FEED-O-MATIC

Automatic treadle feeder 5kg, 8kg, 12kg, 20kg.

Adjustable feed settings

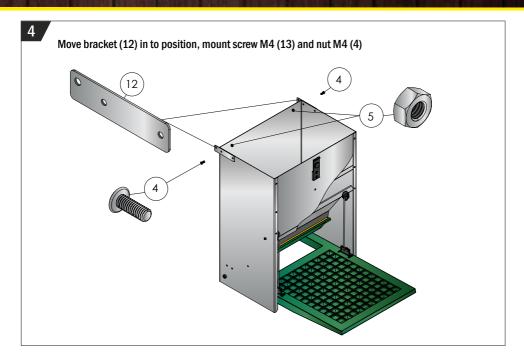
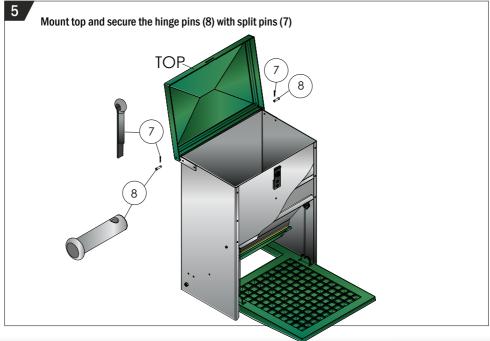
We have made some changes to our Feedomatic treadle feeder. It is now possible to adjust the height of the feed distribution.

In the previous model there was only one setting for the feed distribution (comparable with setting one). Now we have created more settings which allows you to regulate the feed distribution.

We have added an extra backplate to the inclined plate which opens when an animal steps on the treadle. The standard setting is setting one, the difference between each setting is 6 mm. By raising this backplate to setting four, there will be more space (18mm more) for the feed to go through.

Please make sure there is no feed in the feeder when you change the setting.
